SF721

Subject: 18k Front Suspension Shock Absorbers

On behalf of the entities listed below, Daimler Truck North America LLC (DTNA) is initiating Field Service Campaign SF721 to modify the affected vehicles.

PROBLEM: The front suspension shock absorbers bottom out before full travel due to incorrect frame rail hole locations for the upper shock bracket.

Fig. 1, Front Suspension Shock Absorber

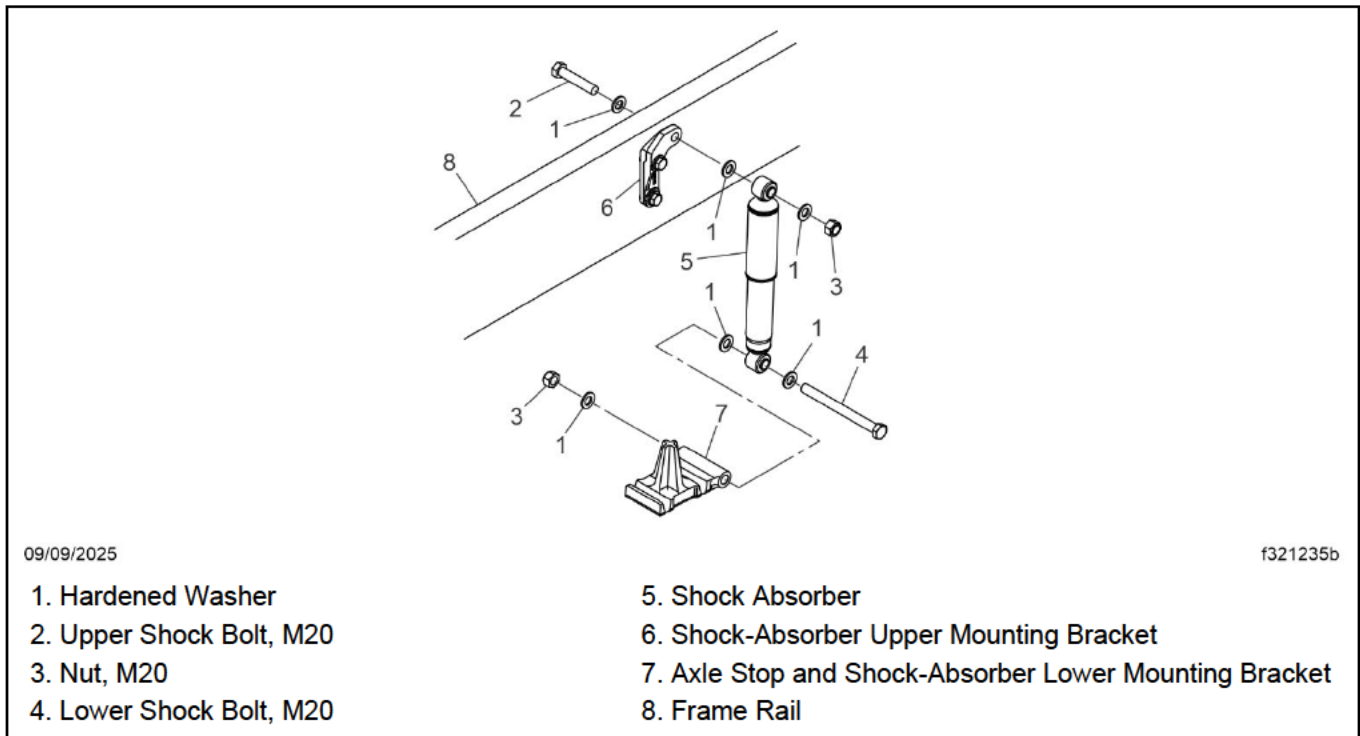
- Remove the upper and lower shock bolts and remove the shock absorber from the upper and lower mounting brackets. See [Fig. 1](#).
- Remove the shock absorber upper mounting bracket. See [Fig. 1](#).

Fig. 2, Repositioning the Shock Absorber Upper Mounting Bracket

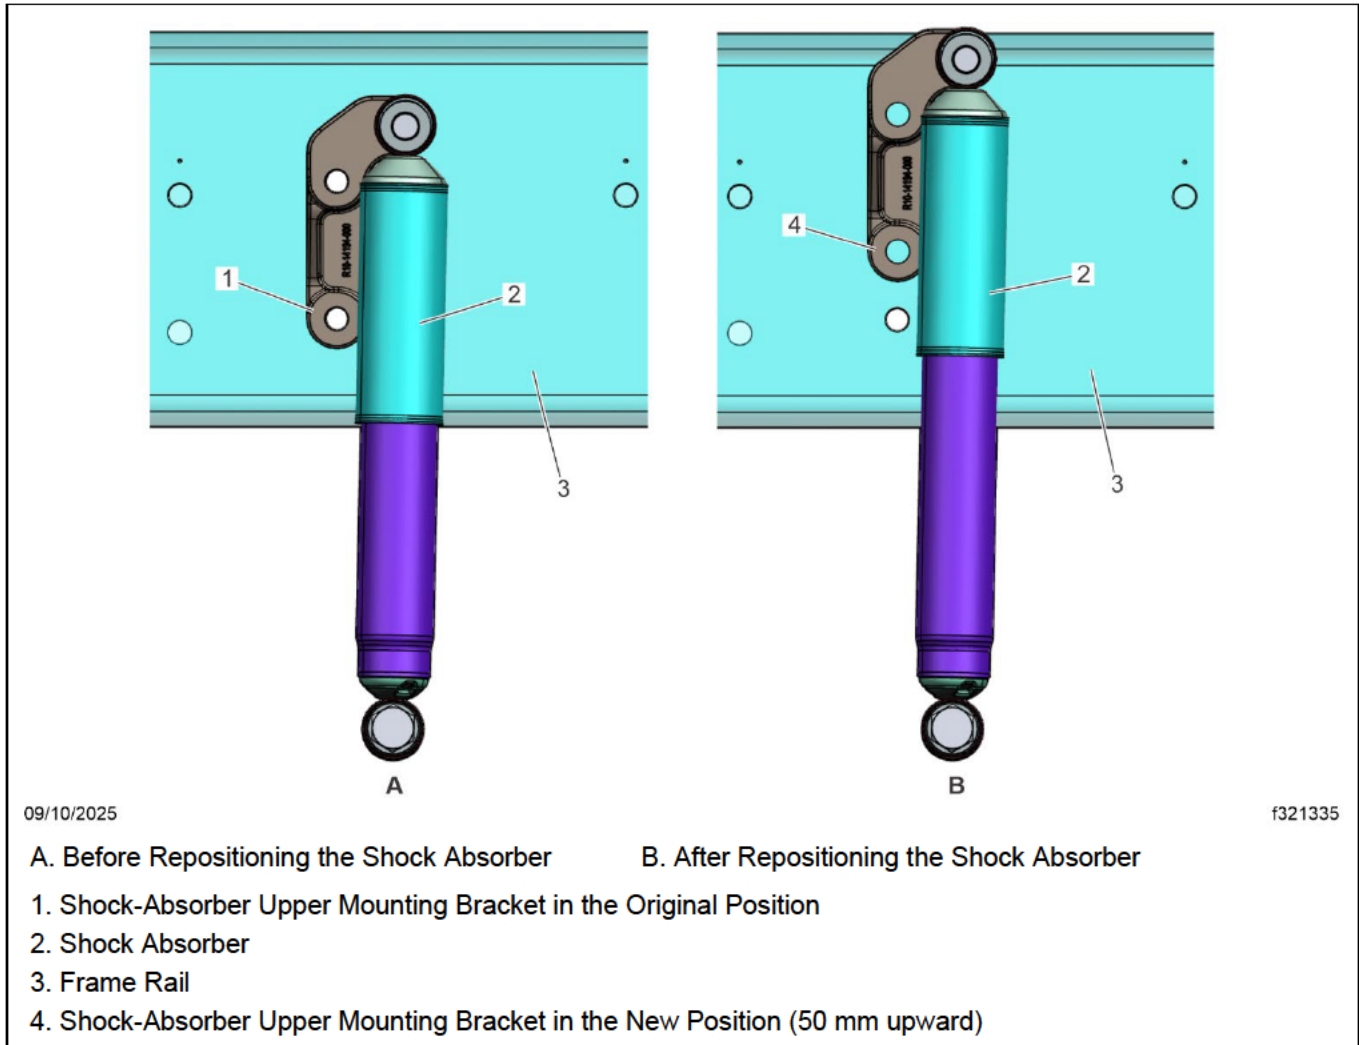
- From the center of the original fastener hole, measure 50 mm upward and mark the location.
- Use a mag drill to drill two holes at the marked location to reposition the mounting bracket.

11. Install the new shock absorber upper mounting bracket and tighten the fasteners 155 lbf-ft (210 N·m). See Fig. 2.

12. Cap the old bolt holes with grade 8 fasteners.
13. Install the new shock absorber.
14. Repeat steps 7 through 13 on the other side of the vehicle.
15. Install the wheels and tighten the fasteners 450 to 500 lbf-ft (610 to 678 N·m).
16. Close the hood.
17. Raise the vehicle, remove the jack stands from the chassis, then lower the vehicle. For instructions to raise and lower the vehicle, see **Group 00** of the applicable workshop manual.
18. Clean a spot on the base label (Form WAR259) and attach a campaign completion sticker for SF721 (Form WAR261).
